# Bridge Square

Archaeology and Design Review

Northfield Historic Preservation Commission Meeting

December 6, 2023

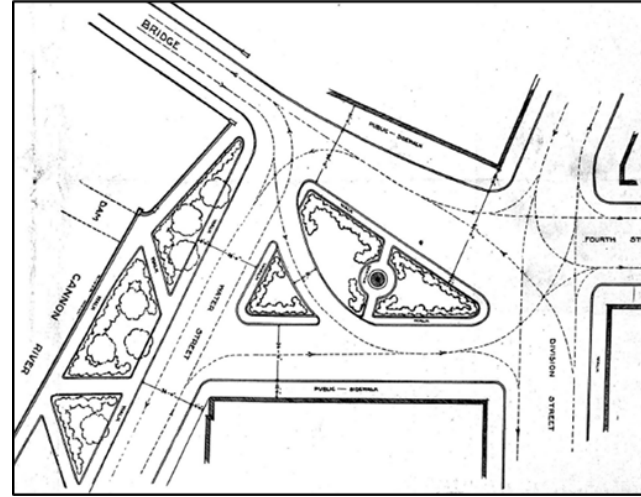
- "Gentler edges and geometry...softening the amphitheater area into a gentler curvilinear shape to follow existing edges and simplifying the pergola."
- "Retain the evolved 'teardrop' shape and characteristic informal openness of Bridge Square's perimeter...avoid overly designed formal planting beds..."
- "The paving and landscaping features and materials proposed throughout the park should be kept to a minimum. Areas and paths created by paving materials...should be kept simple and minimal."

- Geometry of Riverside Park is softened; sweep is retained to emphasize the curve of Water Street; pergola is no longer included
- Central, paved area references 1916 teardrop design; extant of the ca.1975 extension retained as lawn, planting beds, and part of circulation system; planting beds at east end of Bridge Square are no longer included
- Removal of extant curbs to create more free-flowing circulation will be balanced by planting bed walls that protect pedestrian traffic; planting will be lawn or low massing vegetation
